# Access Compliance Report

## Public Rights-of-Way

### (Curb Ramps)

Intersection ID: 24123	Main Street: SOUTH_BRIDGE_CR	Cross Street: SOUTH_POINT_BV	Location: SE
ADA ID: 60AD7AEE2E0C	Ramp Type: Perp	Initial Pass/Fail: Fail	Overall Compliance: No
			Severity Score: 18.75

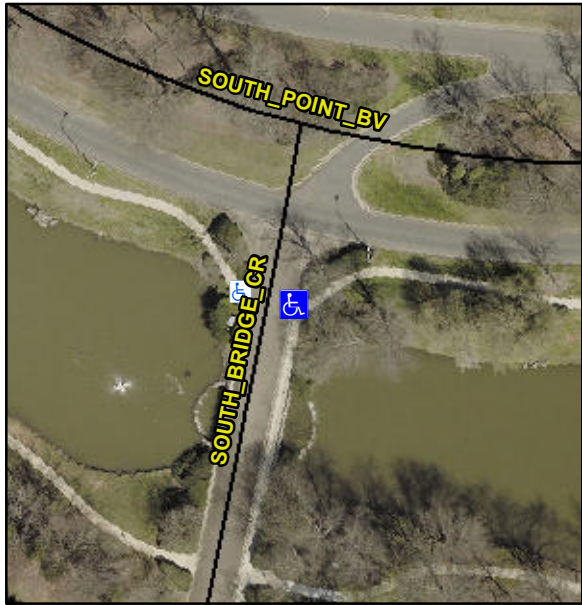
Codes/Mitigation Info/Possible Solution			Field Measurements/Component Compliance					
	Possible Solutions:		Compliance	Description	Data	Compliance	Description	Data
	Remove & Replace Entire Ramp.		N/A	Ramp Length (in)	58.0	Yes	Ramp Slope (%)	6.7
			No	Ramp Width (in)	34.0	No	Ramp XSlope (%)	4.2
			N/A	Flare Type LT	N/A	N/A	Flare Type RT	N/A
			N/A	Flare Slope LT (%)	N/A	N/A	Flare Slope RT (%)	N/A
			N/A	Flare Traversable LT?	N/A	N/A	Flare Traversable RT?	N/A
			N/A	Landing Length (in)	N/A	N/A	DWS Provided?	N/A
			N/A	Landing Width (in)	N/A	N/A	DWS Contrast?	N/A
			N/A	Landing Slope (%)	N/A	N/A	DWS Length (in)	N/A
			N/A	Landing X Slope (%)	N/A	N/A	DWS Full Width?	N/A
Surveyor Notes:			N/A	Landing Curb? (Y/N)	N/A	N/A	DWS Offset (in)	N/A
N/A			N/A	Shared Landing?	N/A			
PROW/ADA:			N/A	Gutter Ponding?	N/A	N/A	Gutter Slope (%)	N/A
Not Found, R304.5.1, R304.5.3			N/A	Gutter Lip Ht (in)	N/A	N/A	Gutter X Slope (%)	N/A

N/A	Painted X Walk1?	No	N/A	Painted X Walk2?	N/A
				X Walk 1 Direction	To W		X Walk 2 Direction	N/A
			N/A	X Walk 1 Width (in)	N/A	N/A	X Walk 2 Width (in)	N/A
				X Walk 1 Slope (%)	3.8		X Walk 2 Slope (%)	N/A
				X Walk 1 X Slope (%)	2.8		X Walk 2 X Slope (%)	N/A
			N/A	Ramp inside XWalk1?	N/A	N/A	Ramp inside XWalk2?	N/A
				Road Slope (%)	N/A	N/A	Clear Space?	N/A
				Road X Slope (%)	N/A	N/A	Clear Space to XWalk (in)	N/A
			N/A	Any Obstructions?	N/A	N/A	Storm Grate/Utility Hazard?	N/A
				Obstruction Type			Storm Grate/Utility Type	
					N/A			N/A
						Yes	Surface Condition? (G/P)	Good
